HARNESS MODIFICATION FOR CPS1853L, CPS1861L, AND CPS1896 USED IN CPA4090L, 4064L, 4078L, 4085L, 4088L. THIS PAGE FOR UNITS THAT HAVE THE STANDARD 3M CONTROL BOARD (NOT NETPLEX)

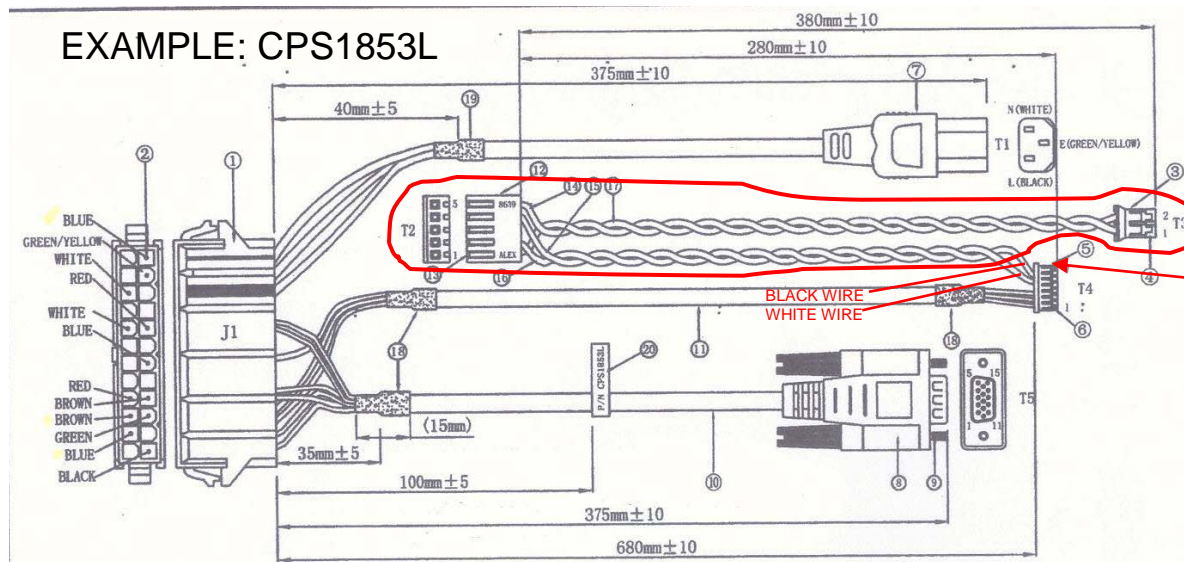
1. DISCONNECT 7-PIN CONNECTOR FROM TOUCH CONTROLLER. CAREFULLY EXTRACT PINS CONNECTED TO BLACK AND WHITE WIRE FROM CONNECTOR T4. AN OBJECT WITH A FINE POINT SUCH AS AN XACTO KNIFE CAN BE USED TO LIFT UP ON THE PLASTIC PIN RETAINER TO RELEASE PINS. DISCARD WIRES CONNECTED WITH T2 AND T3.

3. THIS NEW HARNESS CAN BE PLUGGED BACK INTO THE TOUCH CONTROLLER AND INTO THE A/D BOARD CN13 AS SHOWN BELOW.

2. INSERT BLACK AND ORANGE WIRES OF NEW HARNESS (CPS1862) INTO CONNECTOR T4 AS SHOWN BELOW
